MODIFICATION INSTRUCTIONS
for the
Kodak X-Omat 180 LP PROCESSOR
Service Code: 3227
Modification No. 3
Type 1 Required

Purpose: To prevent solution leakage caused by cracked or broken FITTINGS.

H127_0166BCA
H127_0166BA

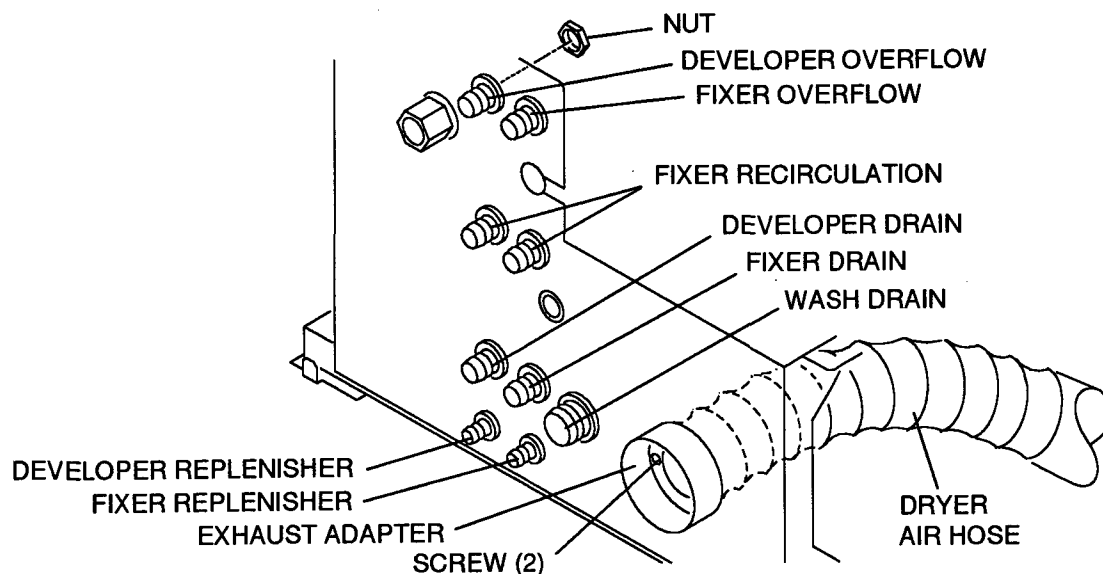
[5] On both sides of the BULKHEAD PANEL, remove the HOSES, NUTS, and existing FITTINGS for the:

- DEVELOPER OVERFLOW
- FIXER OVERFLOW
- FIXER RECIRCULATION

[6] Install the new FITTINGS for the FIXER RECIRCULATION.

- (a) Install the rubber WASHERS in the correct position on the FITTINGS. See the figure at the right.
- (b) Insert the new FITTINGS through the holes in the BULKHEAD PANEL with the rubber WASHERS between the BULKHEAD PANEL and the FITTINGS.
- (c) Install the NUTS on the FITTINGS. Tighten the NUTS **until the NUTS make contact** with the BULKHEAD PANEL.
- (d) Tighten the NUTS an additional $\frac{1}{4}$ rotation to compress the WASHERS.
- (e) Install the HOSES on the FITTINGS.

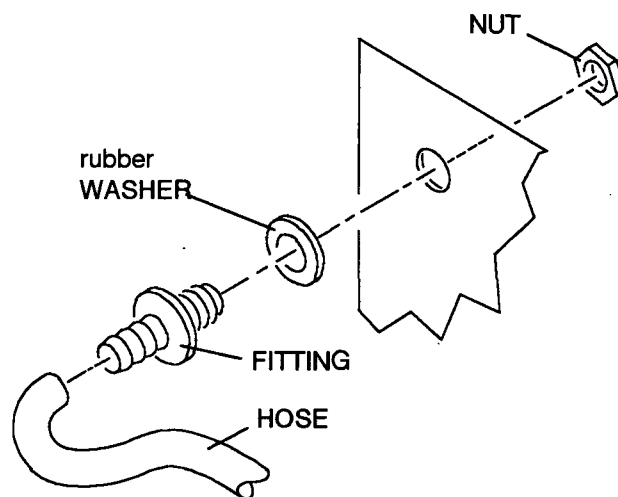
- Install the rubber WASHERS between the BULKHEAD PANEL and the FITTINGS, not between the BULKHEAD PANEL and the NUTS.
- Do not overtighten the NUTS when installing the new FITTINGS.

[7] Do Step [6] for the:

- FIXER OVERFLOW
- DEVELOPER OVERFLOW

H127_0165ACA
H127_0165AC

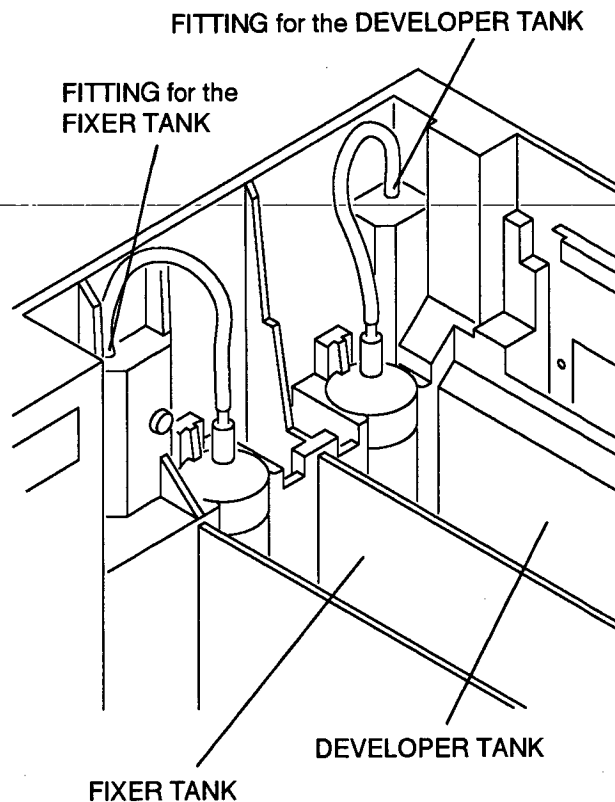
[9] On both sides of the BULKHEAD PANEL, remove the HOSES, NUTS, and existing FITTINGS for the:

- FIXER DRAIN
- FIXER REPLENISHER
- DEVELOPER DRAIN
- DEVELOPER REPLENISHER
- WASH DRAIN

[10] Do Step [6] to install new FITTINGS for the:

- DEVELOPER DRAIN
- DEVELOPER REPLENISHER
- FIXER DRAIN
- FIXER REPLENISHER

[11] Install:

- new FITTING for the WASH DRAIN

The FITTING for the WASH DRAIN has no rubber WASHER.

H127_0173GCA
H127_0173GA

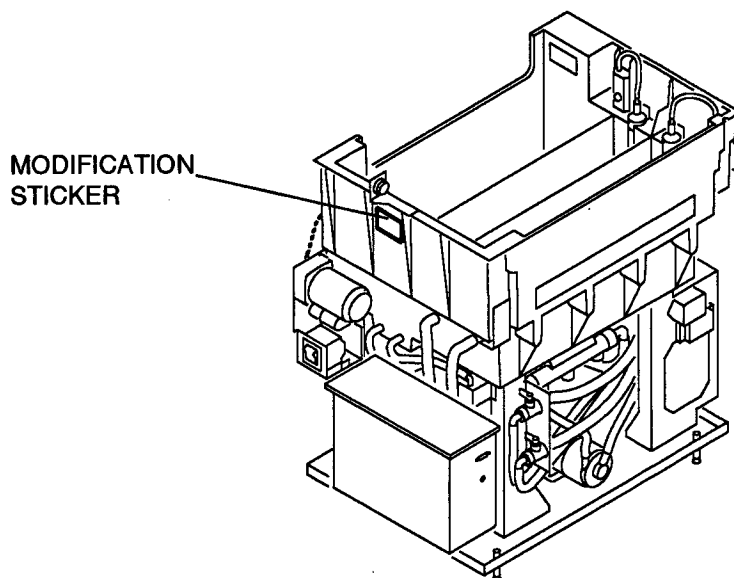
- [12] Remove the HOSES, NUTS, and existing FITTINGS for the:

- DEVELOPER TANK
- FIXER TANK

- [13] Install the new FITTINGS for the DEVELOPER TANK and the FIXER TANK:

- (a) Install the rubber WASHERS in the correct position on the FITTINGS.
- (b) Insert the new FITTINGS through the holes in the TANKS with the rubber WASHERS between the TANKS and the FITTINGS. See the figure on page 4.
- (c) Install the NUTS on the FITTINGS. Tighten the NUTS until the NUTS make contact with the wall of the TANKS.
- (d) Tighten the NUTS an additional $\frac{1}{4}$ rotation to compress the WASHERS.
- (e) Install the HOSES on the FITTINGS.
